ADDENDUM NO. 5
DTCC OFFICE OF THE PRESIDENT
BID PACKAGE B
Dover, Delaware 19904

March 19, 2013

The contract documents for the above referenced project, dated February 5, 2013 are amended as follows:

SECTION 130661 - BULLET VOICE AROUND WINDOW

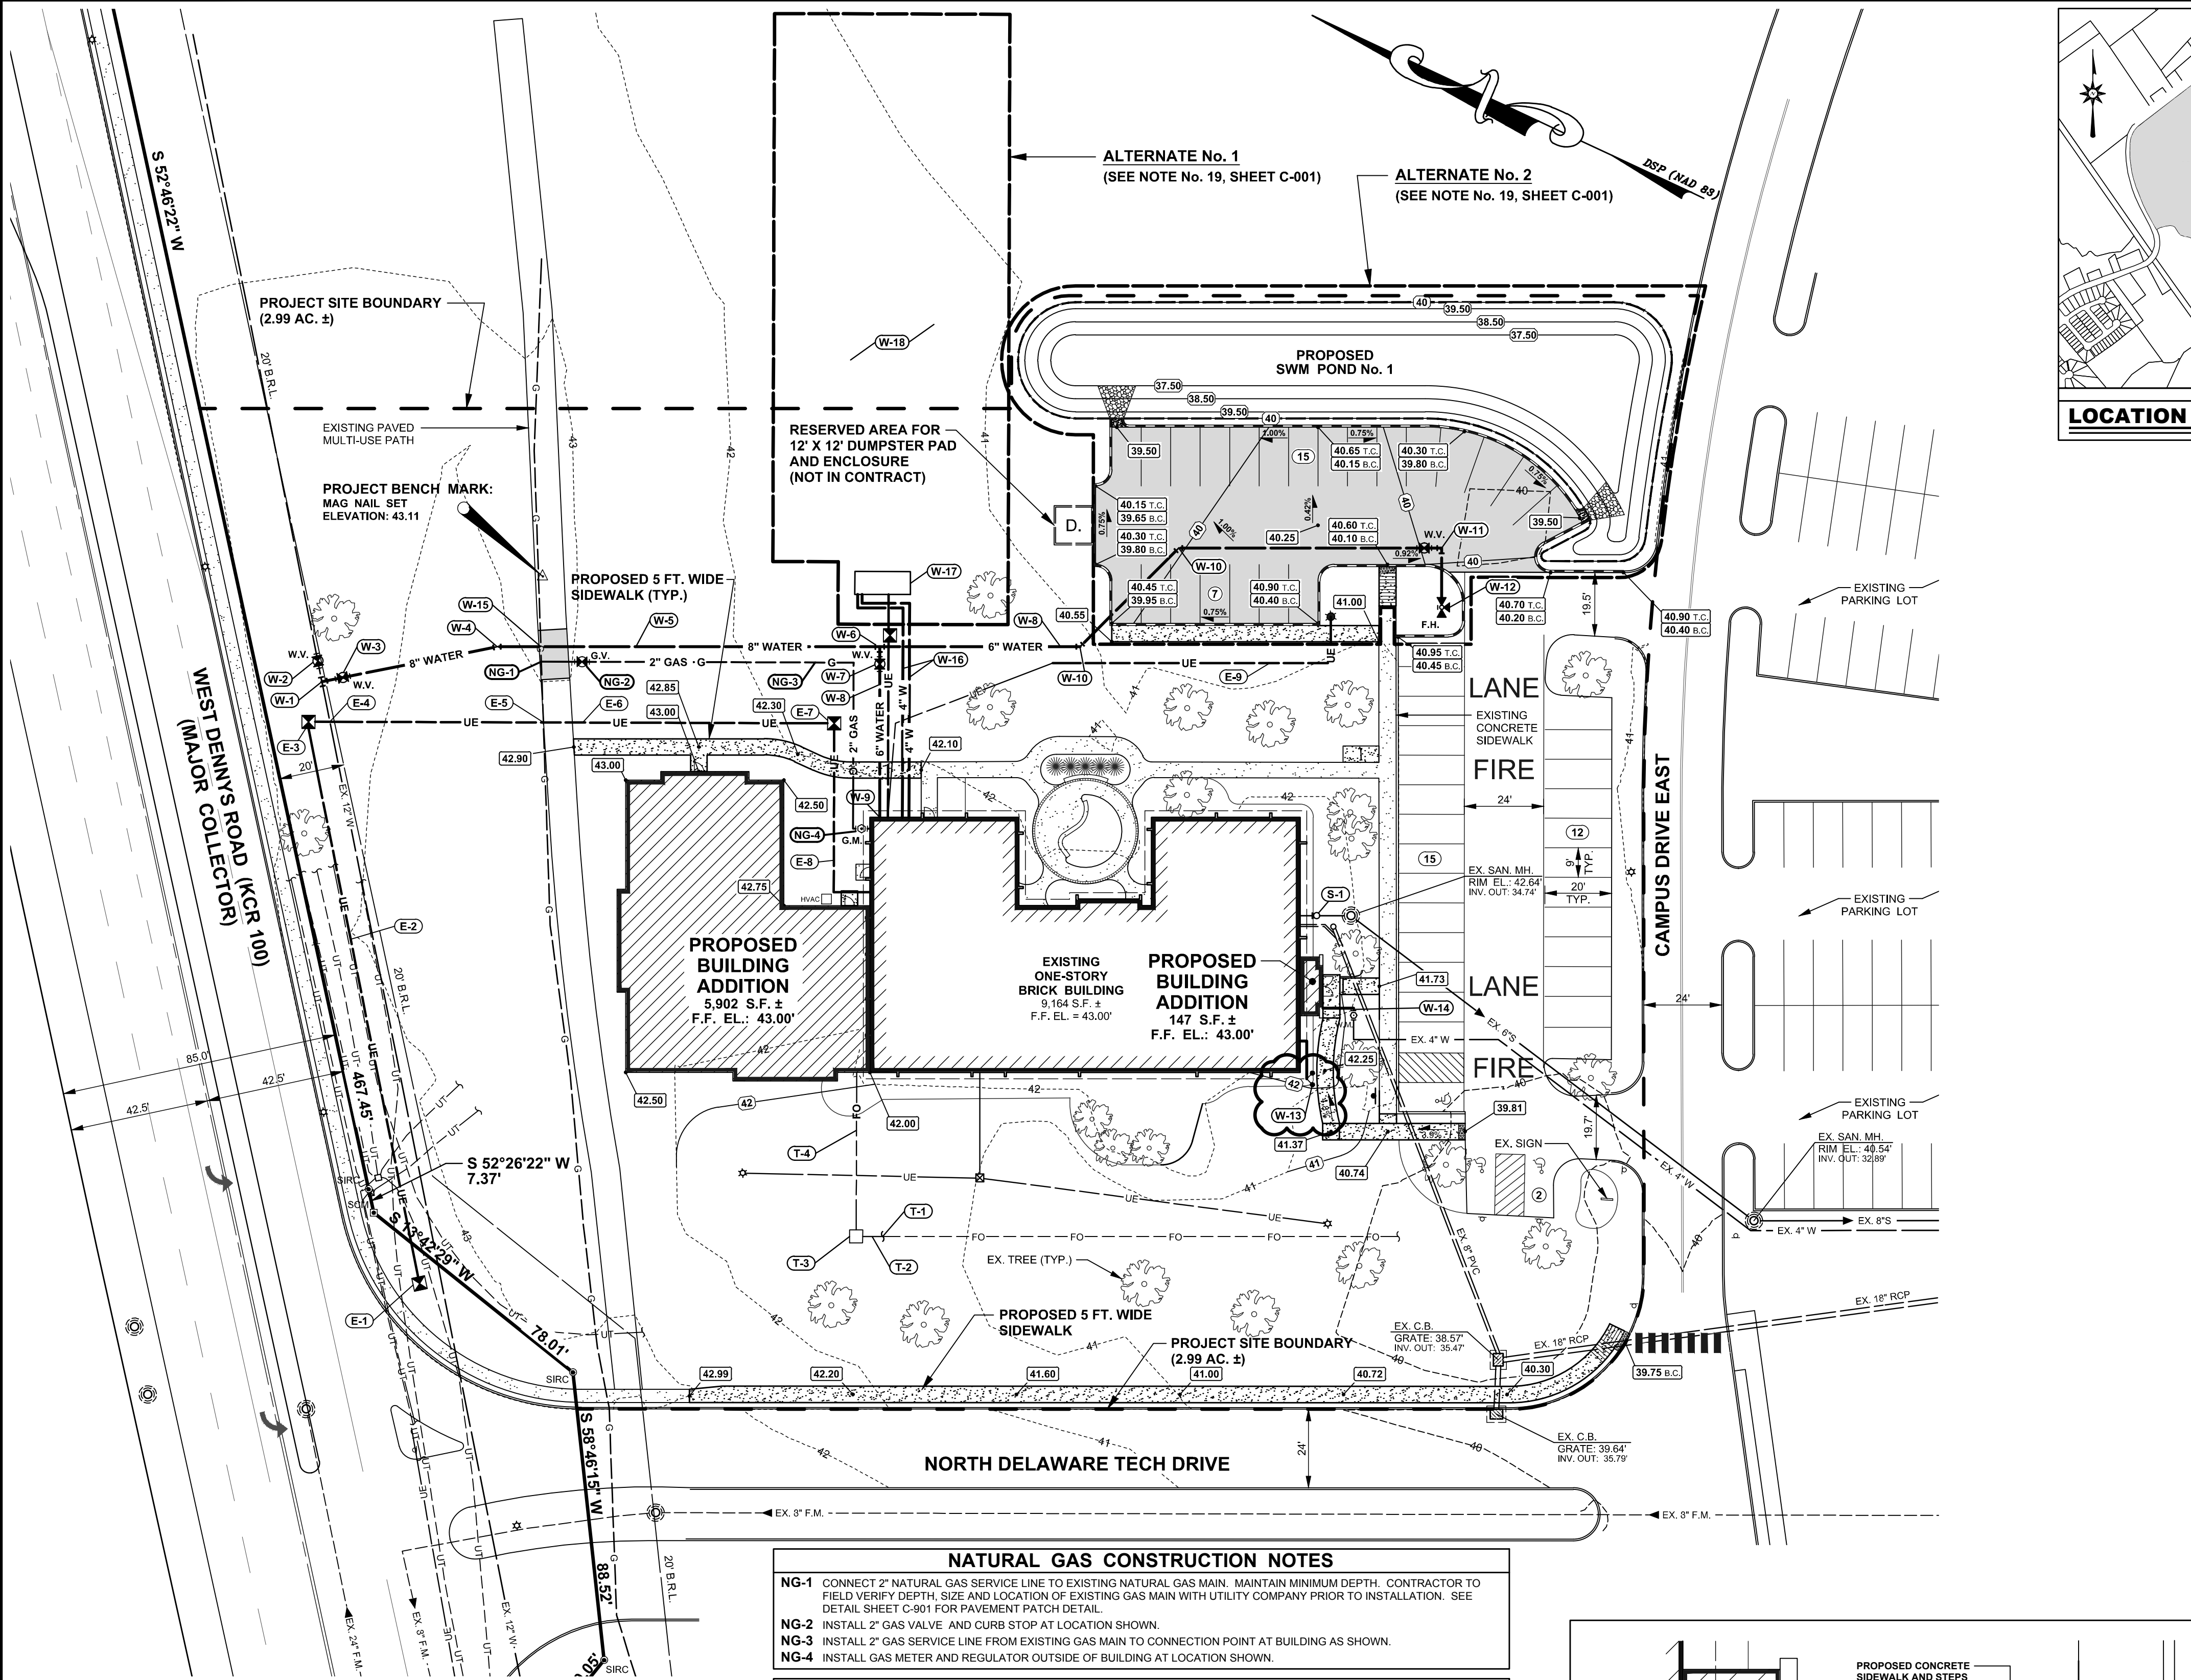
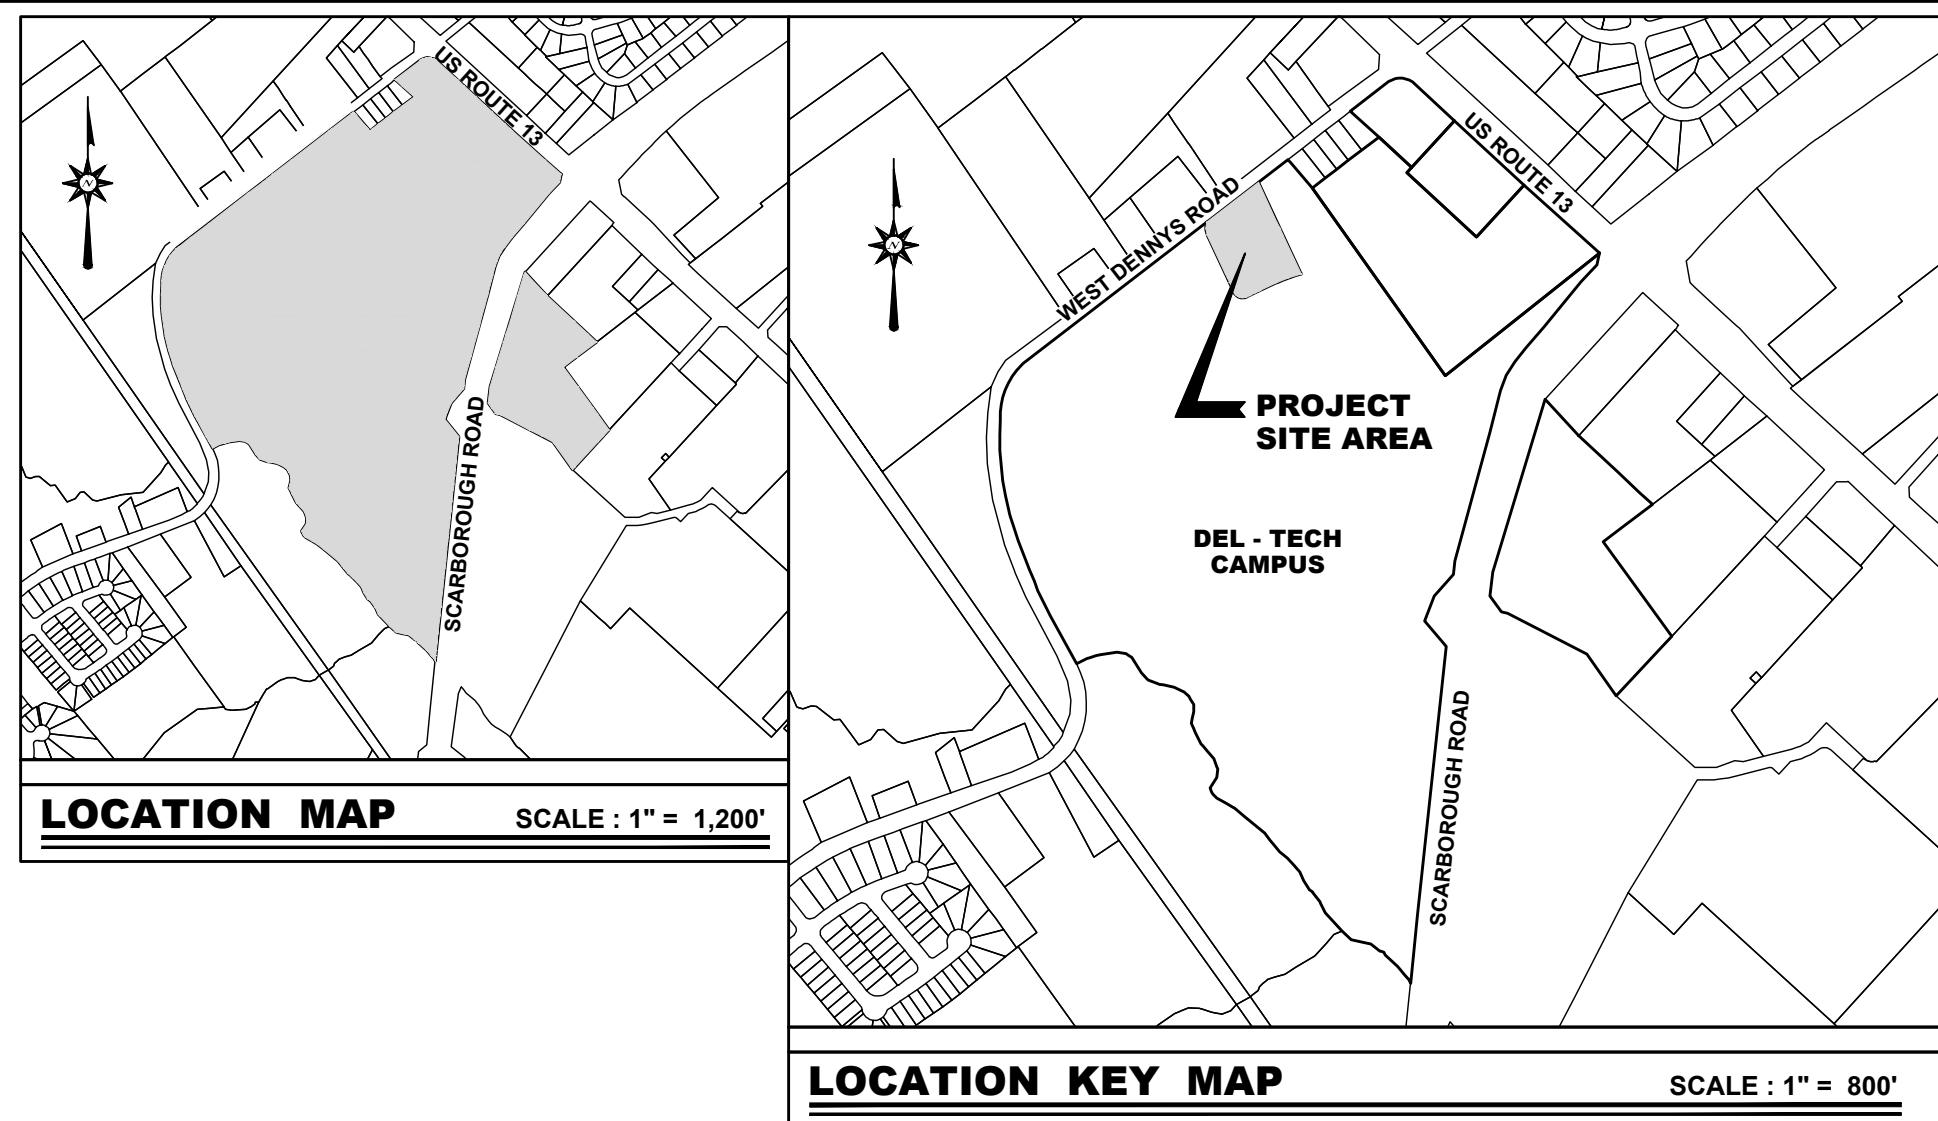
- Section 13 06 61 – Bullet Voice Around Windows: ADD Specification Section 130661 - Bullet Voice Around Windows, dated 03/13/13.

C-301

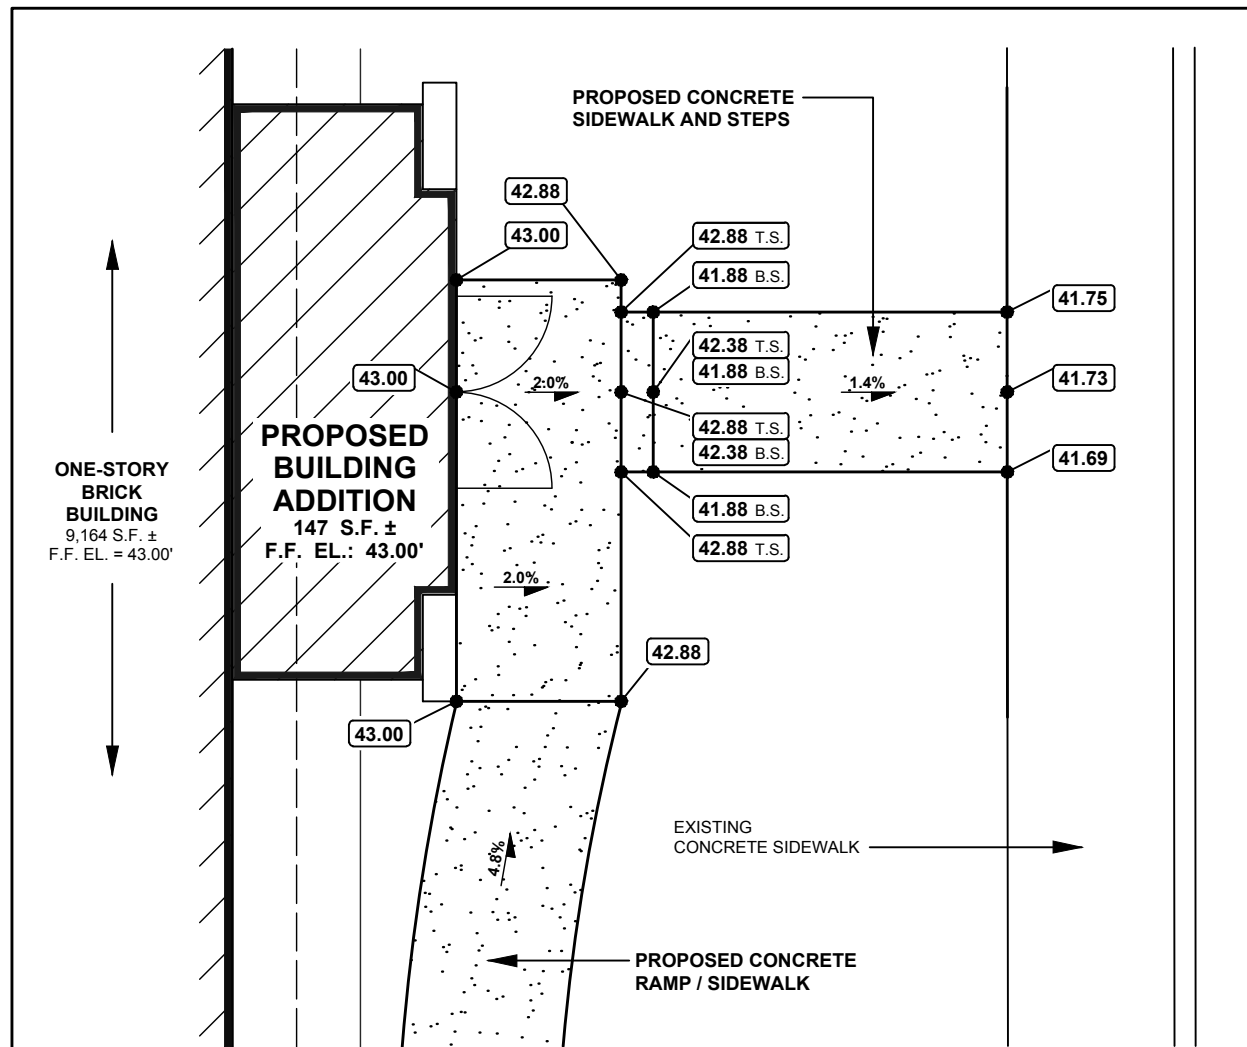
- W-12** INSTALL 6" WATER MAIN 6" ISOLATION VALVE AND BOX AND FIRE HYDRANT AT LOCATION SHOWN. SEE DETAIL SHEET C-902.
- W-13** INSTALL FREE STANDING 8" STORY TYPE FIRE DEPARTMENT CONNECTION APPROXIMATELY 5 FT. OFF SOUTHWESTERN CORNER OF BUILDING AT EDGE OF PLANTER AREA. SEE FIRE PROTECTION SPECIFICATION AND PLANS FOR MATERIALS. INSTALL "FIRE DEPARTMENT CONNECTION" SIGN PER DELAWARE STATE FIRE PREVENTION REGULATIONS. SEE DETAIL SHEET C-901 FOR SIGN DETAIL.
